<b>Project Title</b>	CTR Candeias Landfill Gas Project
<b>Project Reference</b>	1724.V1
<b>Report Date</b>	10 March, 2011
<b>Client Name</b>	International Bank for Reconstruction and Development (IBRD) as the Trustee of the Spanish Carbon Fund, World Bank Group
<b>Client Address</b>	1818 H Street, NW Washington, DC 20433 USA

<b>Version Control</b>	<b>Date</b>
Version 01	13 January 2010 (Draft Validation Report)
Version 02	10 March 2011 (Final Validation Report for Brazilian DNA)

<b>Project Title:</b>		CTR Candeias Landfill Gas Project	
Project Location		Municipality of Jaboatão dos Guararapes in the Recife Metropolitan Area	
Country:		Brazil	
Project Parties		Brazil Kingdom of Spain	
Project Participants		Haztec Tecnologia e Planejamento Ambiental SA International Bank for Reconstruction and Development (IBRD) as the Trustee of the Spanish Carbon Fund	
Methodology used		ACM0001 "Consolidated baseline and monitoring methodology for landfill gas project activities"	
Methodology version number		11	
Estimated Annual Average Emission Reductions		155,112	
Crediting Period Dates		01 August 2011 to 31 July 2018	
GSP PDD Version	Date: 19 June 2009	Final PDD Version	Date: 08 March 2011
	Ve

**Figure 1. Comparison of O&M costs of other similar registered projects generating electricity from landfill gas registered under methodology ACM0001, for which data is available**

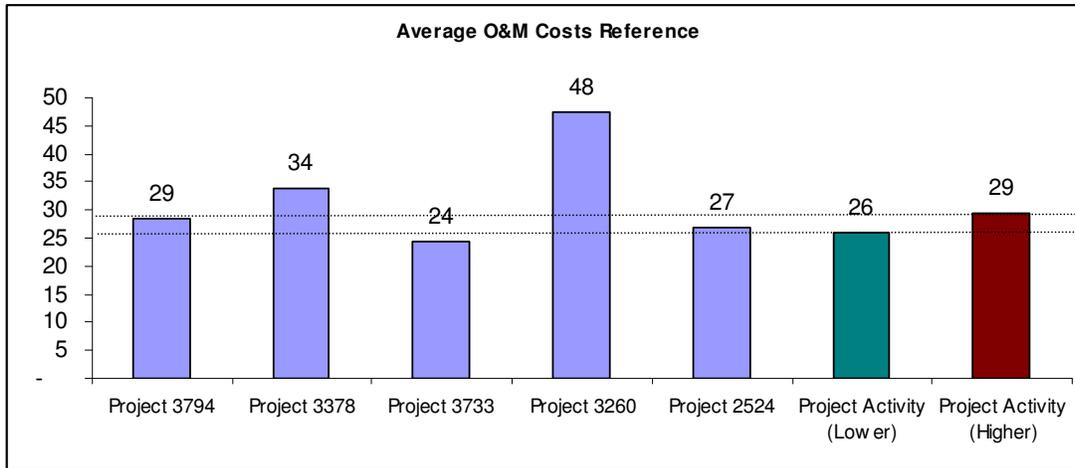
The comparison indicates that the O&M costs are reasonable compared to the range of costs observed on other similar projects that have recently been developed.

**Figure 2: Historical electricity prices for other generation sources in the northeast region of Brazil**

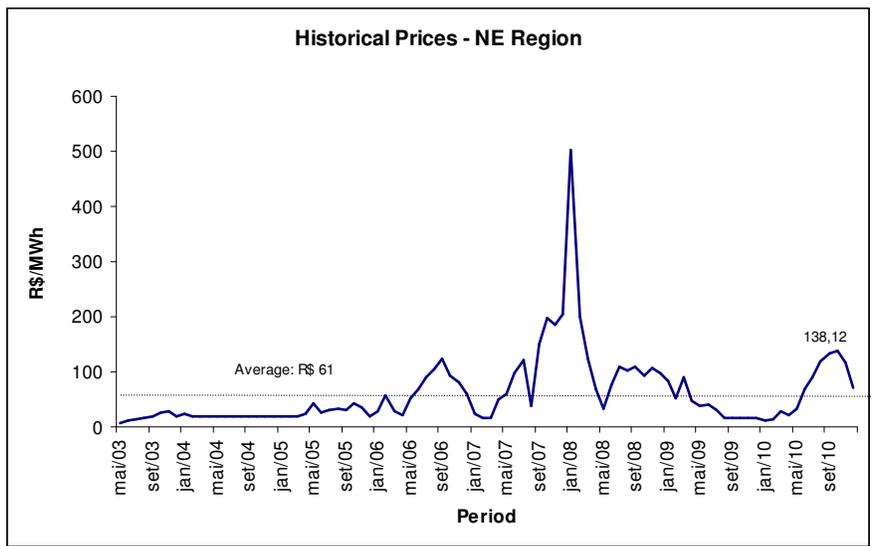
The price assumed for the electricity tariff is based on the latest available Alternative Energy Auction (R\$ 148.39/MWh) in Brazil dated on 26 August 2010, as described above. In order to reach the benchmark, the electricity tariff would have to be 13% higher than this. Electricity prices vary according to region, demand, generation type and power plant capacity. An auction for the kind of energy that is going to be sold by the PPs happened only twice, in 2007 and 2010. Therefore it is difficult to make assumptions on the tariff used in the project. However, considering the historical prices for all other sources of energy in Brazil's Northeast region it is possible to see that the price level assumed by the PPs is among the highest ones of the market (except for January 2008 prices, when the market went through a crisis due to a long period of very low rainfall). The historical electricity price for other generation sources in the northeast region of Brazil is presented in the graphic below, based on the database of the Electricity Energy Commercialization Bureau (CCEE - Câmara de Comercialização de Energia Elétrica) [DR49; DR59]. The average price paid to all power plants in the Northeast Region grid between 2003 and 2010 was R\$ 61/MWh, much lower than the electricity price assumed for the project activity financial analysis.
